# **Intel® Ethernet Controller 82571EB/82572EI/82571GB/ 82571GI Specification Update**

**Revision 6.8  
November 2014**

## 4. MDI Return Loss Is Marginal Near 40MHz at 115ohm Load.

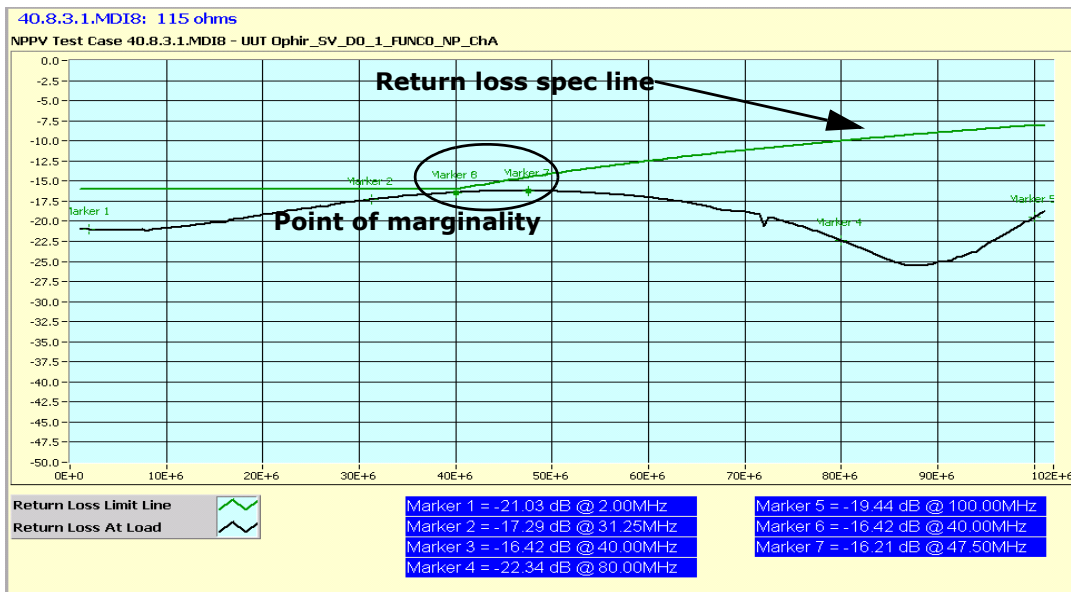
Return loss for 115 ohm load is marginal (Gigabit IEEE specification Section 40.8.3.1) near the frequency of 40MHz. Return loss is acceptable throughout the rest of the frequency spectrum and conforms to the 10Base-T and 100Base-TX specification limits.

IEEE conformance is marginal. There is no impact on system-level performance.

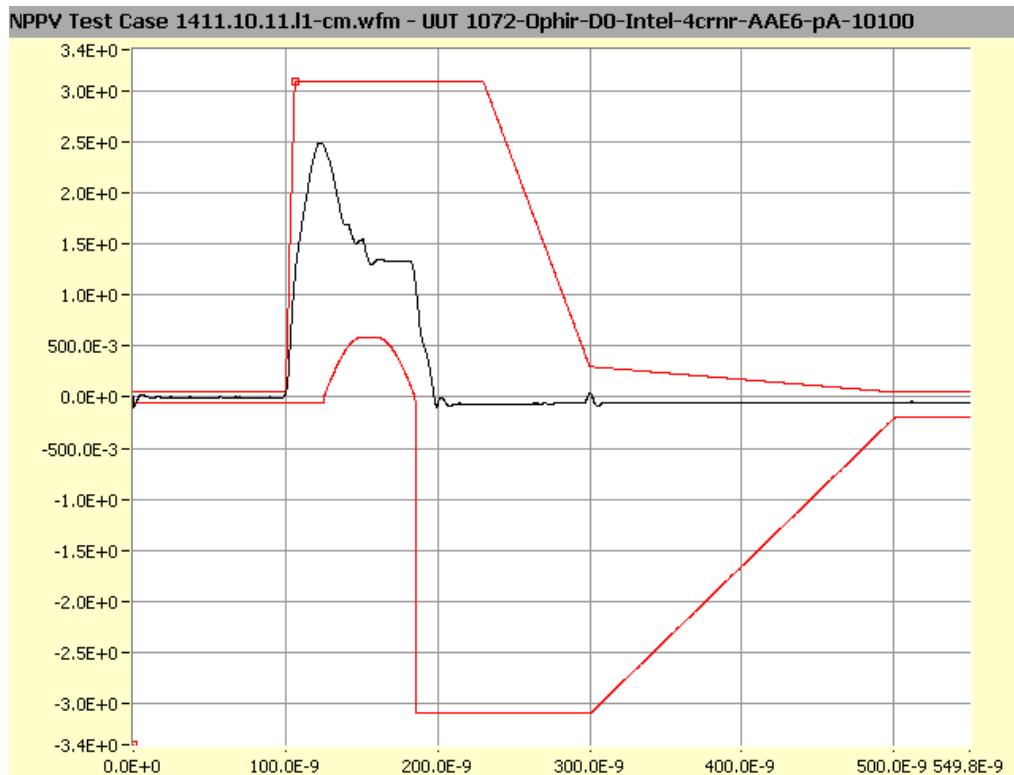
The BMC should not transmit with an IPG lower than 30usec.
